DMC5

Firmware changes / Update notices

Version 2.7

15.2 Update notice

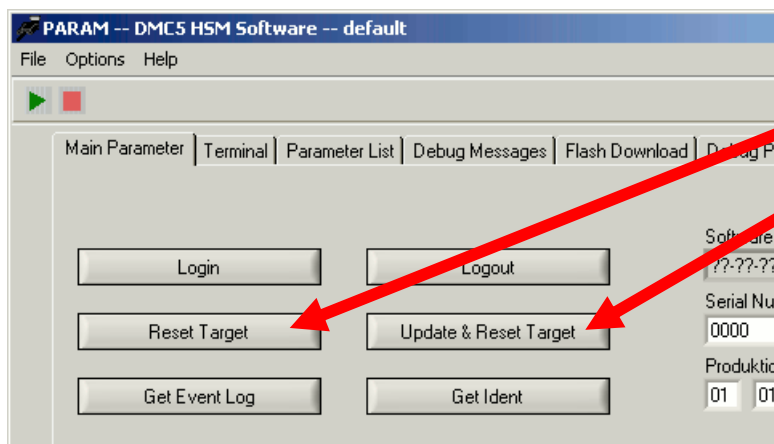
The reorganisation of some internal data and the building of all initial CRC values need some special task when updating from an old firmware. Most of these tasks are done automatically on the first run of the new firmware. If the DMC starts without any errors the update process was successful. Keep in mind that the PARAM tool will not work properly with the wrong XML file.

New Buttons:

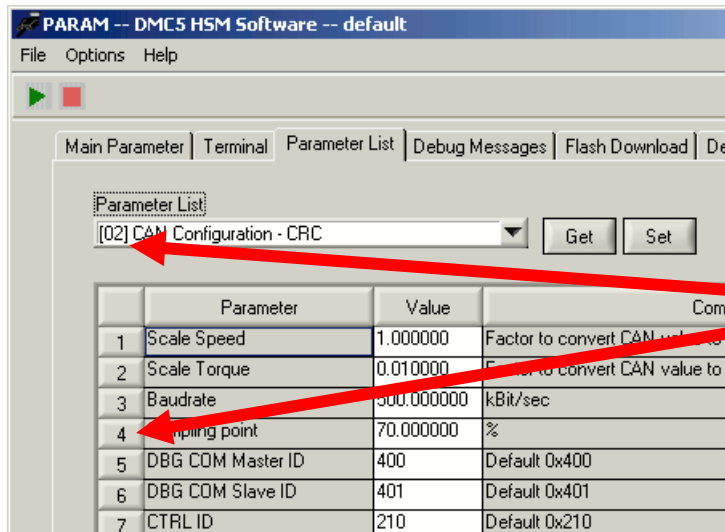
For the full functionality the PARAM Tool Version 01-00-05 or higher is needed. The updated PARAM has an "Update & Reset Target" Button on the first tab which will send a command to the DMC5 to recalculate and update all CRC parameters. The DMC5 will also reset the microcontroller and restart with the changed parameters. This procedure has to be done after every change of a parameter. If this procedure is missed the DMC5 will reset the changed parameter to it's previous values.

- Reset Target
- Update & Reset Target
Update all CRC and reset the target DMC.
